Appendix E

RE: Delta Modeling – Additional Information

Ecosystem Sciences conducted two hydraulic analyses (using HEC-2) for the LORP EIR/EIS related to the Delta. The first analysis was conducted in May 2001 to estimate the water depth, width, and flow velocities for two cross sections in the center of the Delta. Results of the first analysis were provided in an e-mail dated May 22, 2001. They included Excel spreadsheets for both transects using two different Manning's "n" values, discharges from 7 to 150 cfs, and an unknown stream gradient.

delta-sum.xls

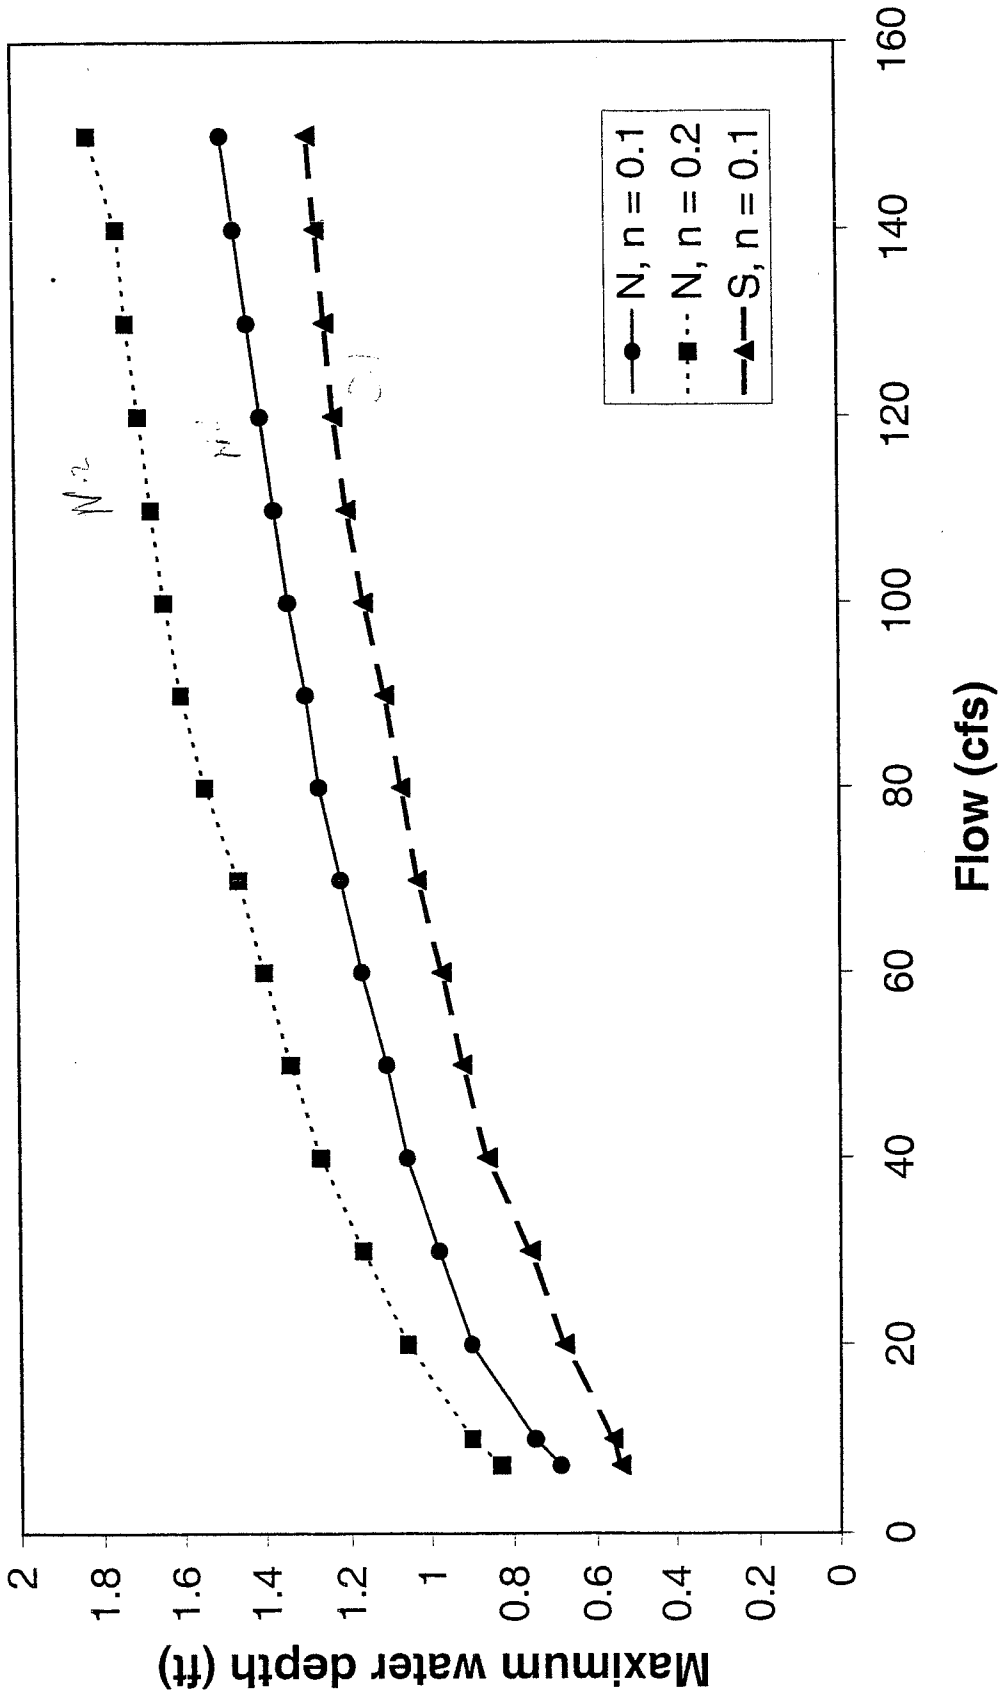
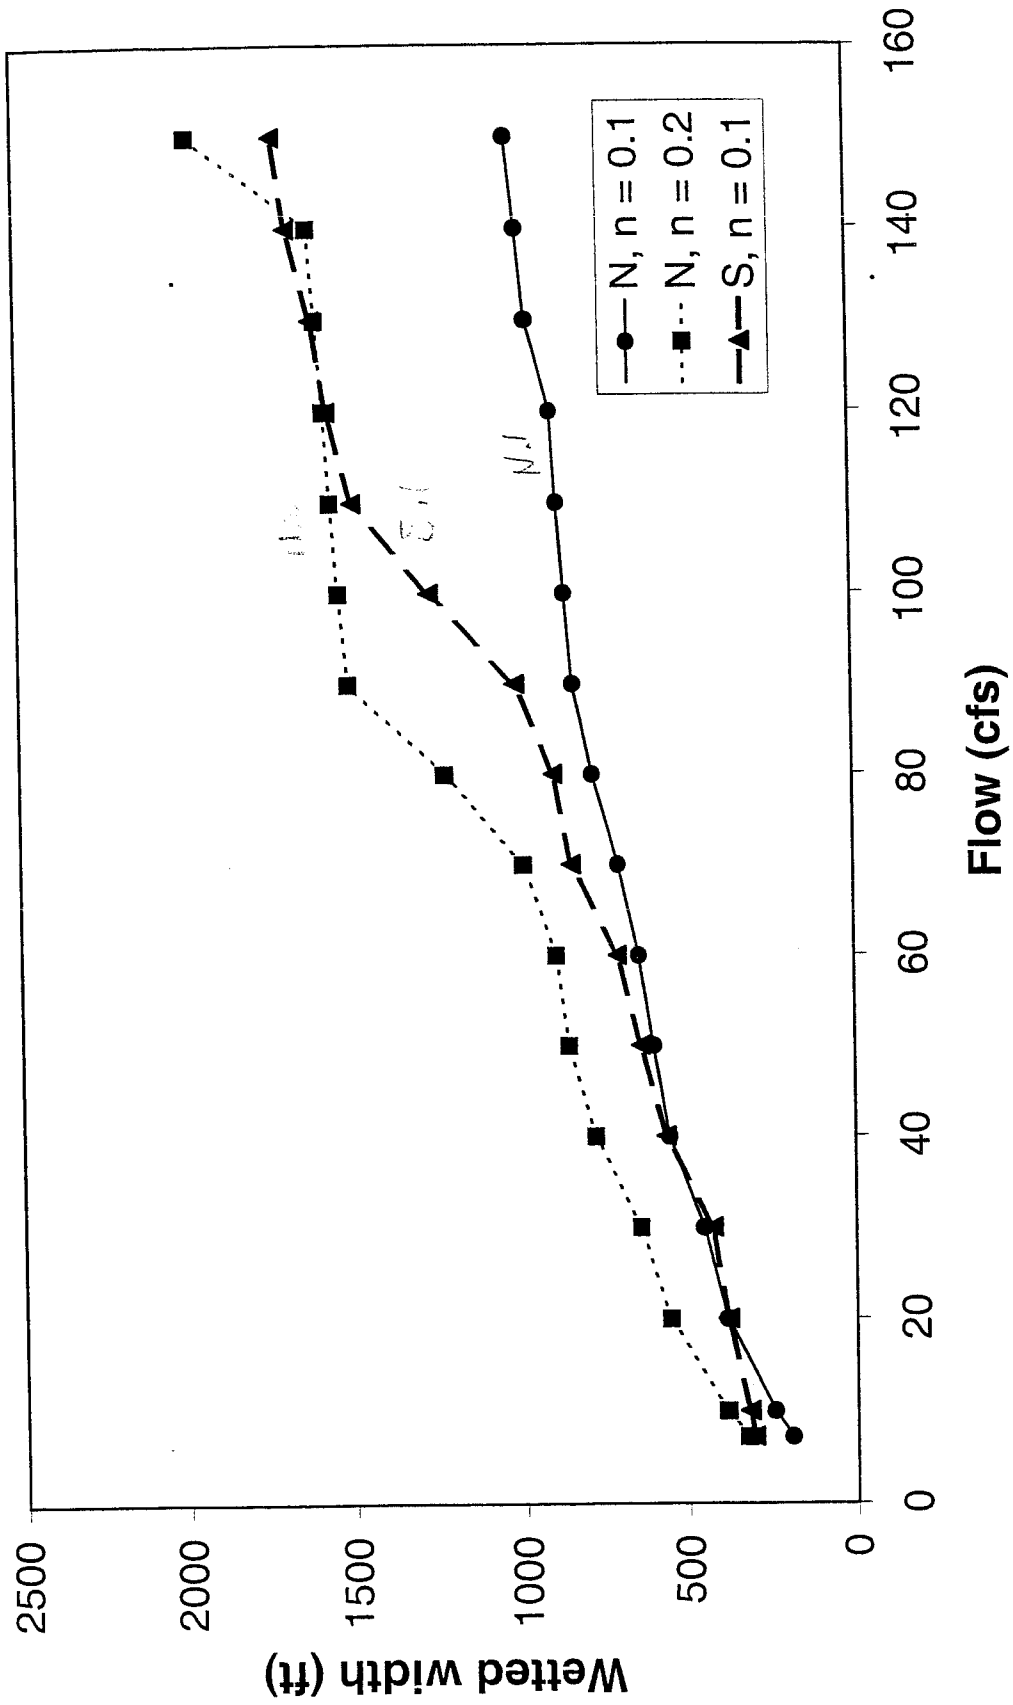
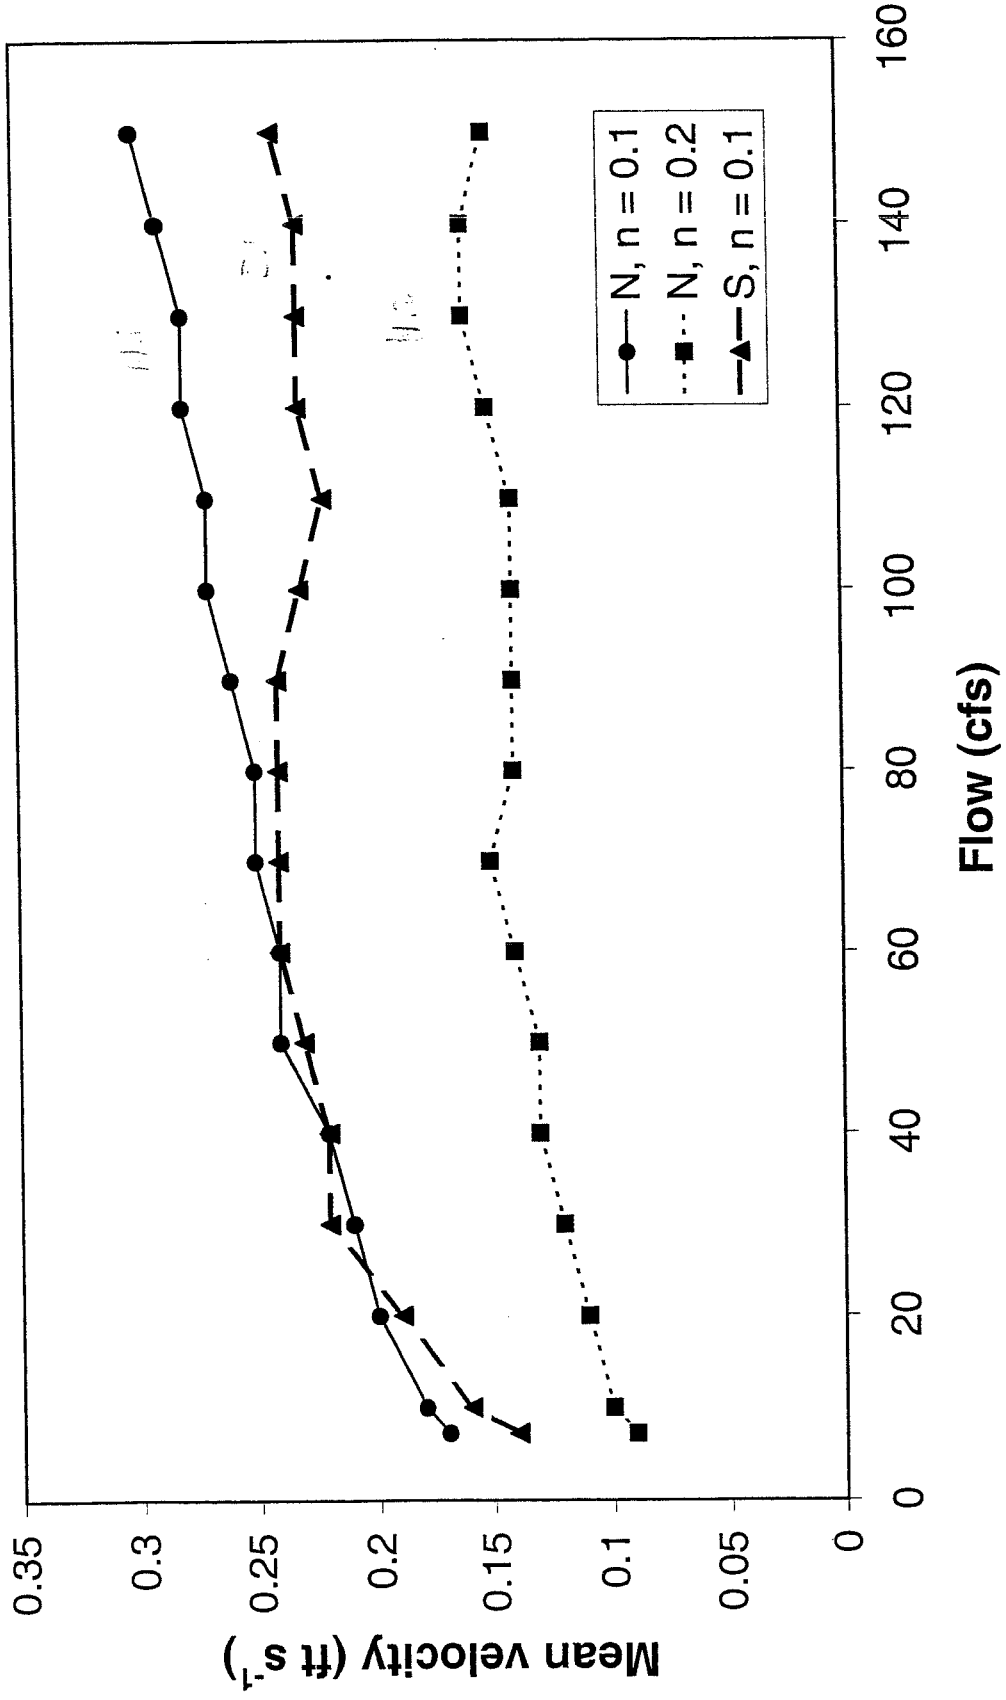
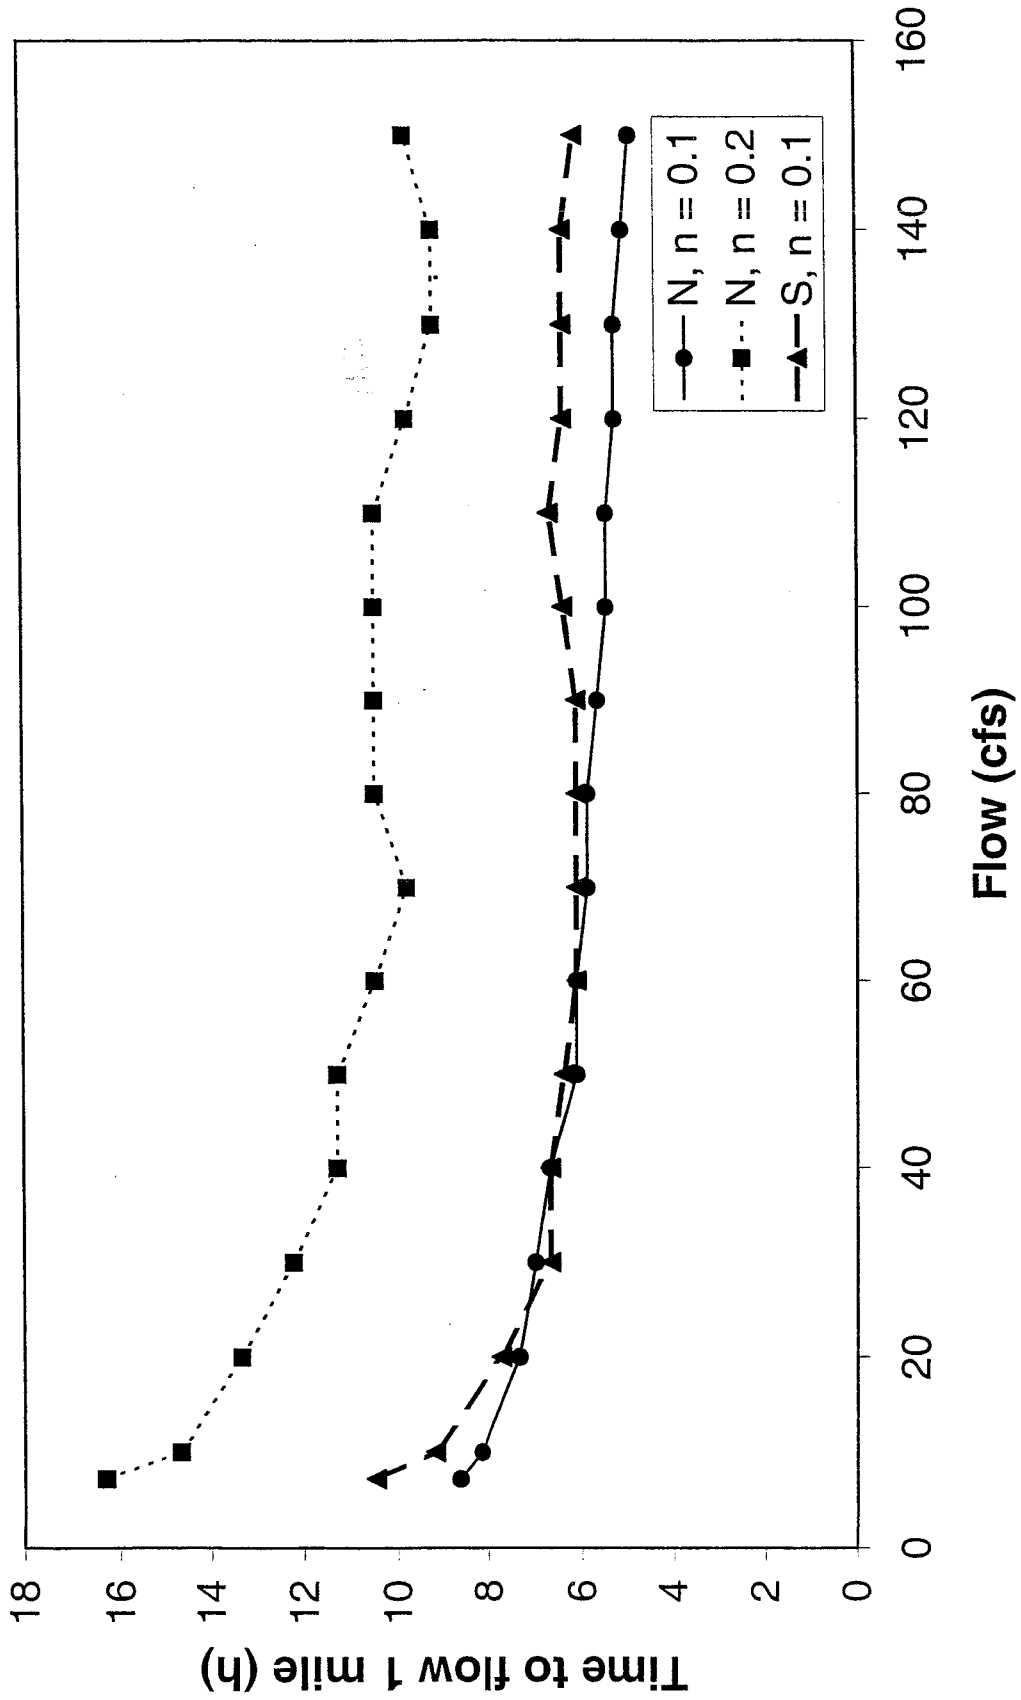
1. Can you fax me the locations of the new transects to be taken at the upper and lower end of the Delta? (fax 805-964-0259)
2. For the final product, would you display the graphs of water depth, width and velocity for three "n" values for both transects (total 6 lines), putting each transect on a different graph. Add a third "n" value of 0.07 to provide a lower range that may reflect better conveyance conditions in the Delta after the LORP has been operative for a long time.

3. Could you provide a spreadsheet that shows water and ground elevations at each transect interval for varying flows so that we can see where the low point is located, determine if spreading is occurring more to the east or west parts of the transect, and calculate an average depth across the transect for various flows. I am assuming that the "depth of water" graph refers to the maximum depth along a transect for a given flow, right?
